# CITY OF CONWAY, ARKANSAS HISTORIC DISTRICT COMMISSION

May 27, 2026

A. 330 Ash St (HDR-0526-0062) New single-family residence

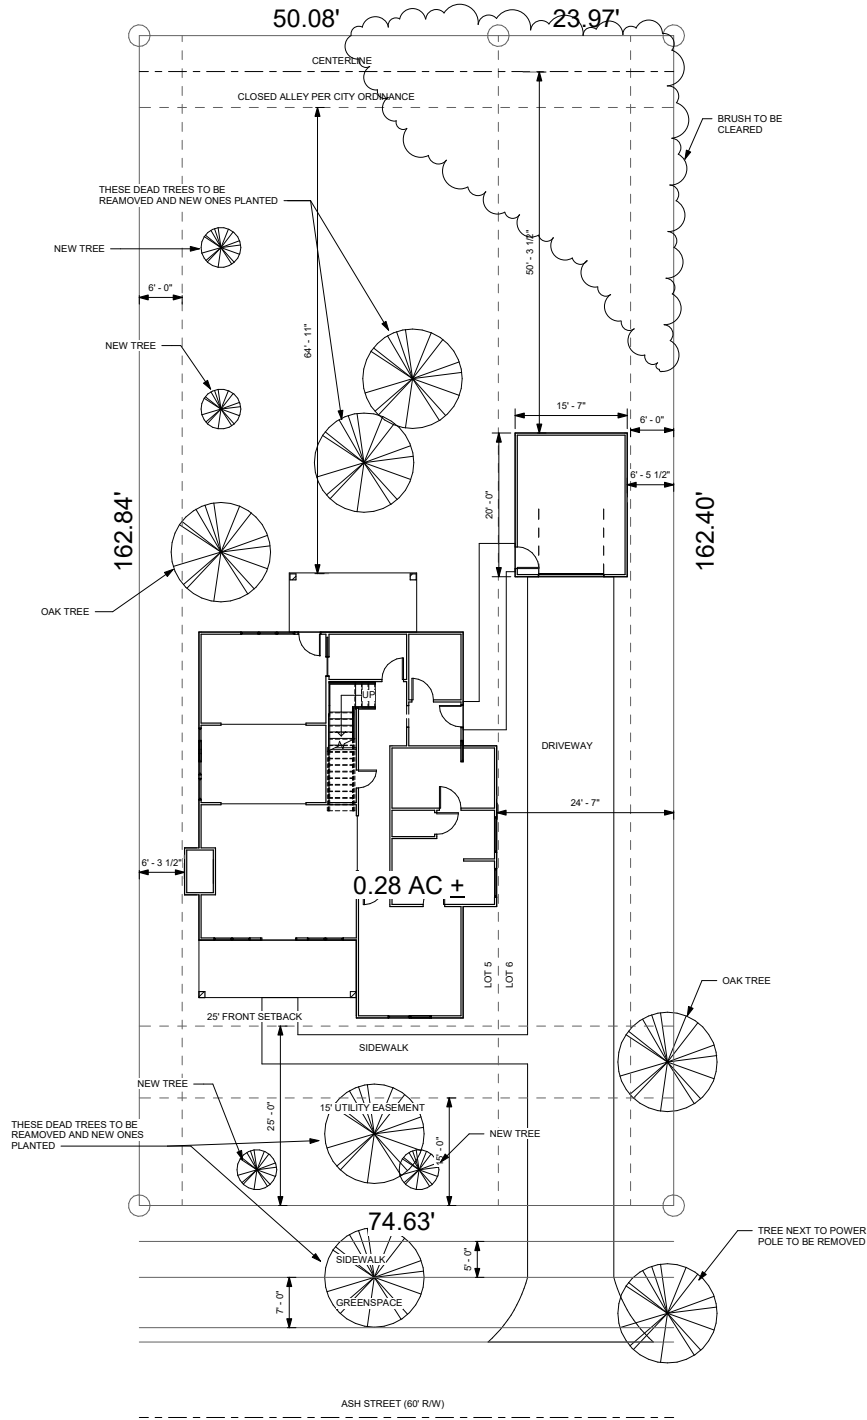
*The predominant front setback is 25' from right-of-way. The applicant is proposing an approximately 27' setback. The exact number must be confirmed prior to building permit issuance, but the proposal is in conformance with district standards. The proposal conforms to all primary structure setback requirements.*

*The proposed garage is detached and behind the primary structure. It conforms to side and rear setbacks. The site plan does not show the distance between the primary structure and the garage, which will need to be verified prior to issuance of a Certificate of Appropriateness. The site plan shows the distance from the centerline of a closed alley. Because the alley has been closed via ordinance, the applicant is not required to verify distance from centerline.*

*The applicant has indicated a driveway off Ash St near the southern property line. The material type is not specified.*

*No HVAC equipment is shown on the site plan.*

2. Property must be replatted prior to building permit issuance.
3. Prior to issuance of a Certificate of Appropriateness, the applicant must submit a revised site plan showing:

- Exact front setback
  - Distance between primary structure and outbuilding at their closest point
  - Distance to the rear property line rather than the centerline of the closed alley

- The driveway material type
  - The height of the proposed structure
  - Depth of front porch
4. Driveway shall be concrete, concrete ribbon, pavers, or permeable paving.
